March 23, 1976

DOCKET 50-255, LICENSE DPR-20
PALISADES PLANT, ANSWER TO
QUESTION ON LOCA (4.A.7)

Question 4.A.7

FIGURE 1 RELAP4-EM HOT CHANNEL
HOT SPOT FLUID TEMPERATURE
1.0 DES/PD

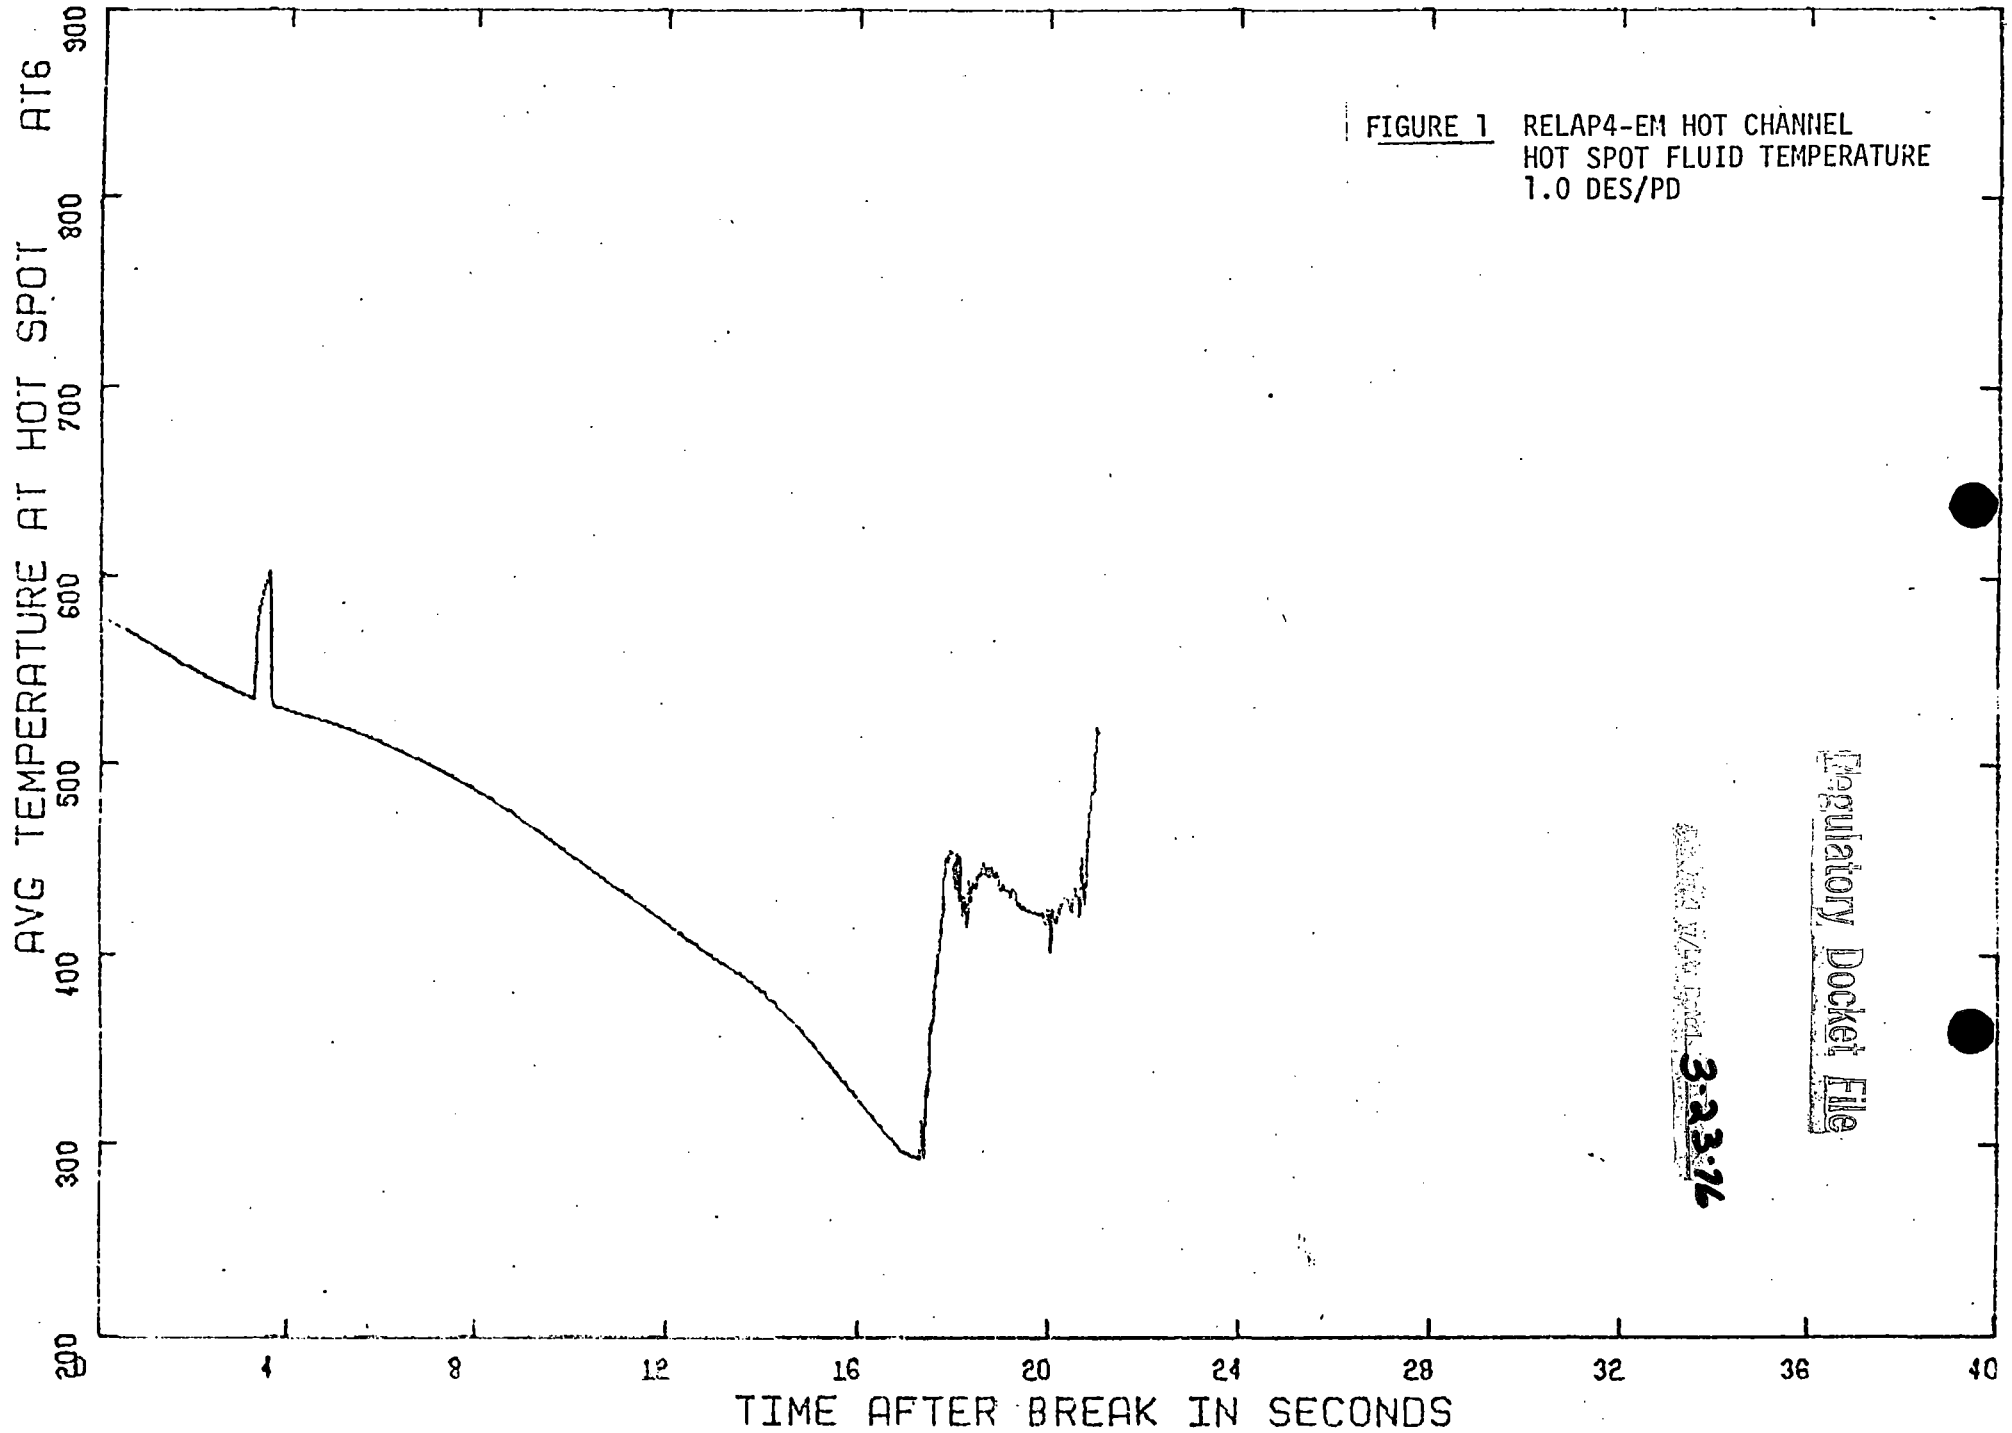
1. Reactor coolant temperature versus time at the hot spot.
2. Average fuel temperature at the hot spot.
3. Hot assembly flow rate.
4. Quality at the hot spot.
5. Gap conductance versus time at hot spot.
6. Hot rod internal pressure.
7. Rupture time.

1. The average fluid temperature in Volume 6 of the hot channel model (Figure 1).
2. The volumetric average fuel rod temperature for heat transfer Node 22 of the hot channel model (Figure 2).
3. Hot assembly flows at inlet Junction 10 and outlet Junctions 11 and 12 for the hot channel model (Figures 3, 4 and 5).
4. Average quality of Volume 6 of the hot channel model (Figure 6).
5. Gap conductance for the maximum power node for both blowdown and reflood and gap conductance for the PCT node during refill and reflood (Figures 7 and 8).
6. The hot rod pin pressure during the entire transient (Figure 9).
7. Rupture time for the 1.0 DES/PD was calculated to occur at 49.82 seconds after the break.
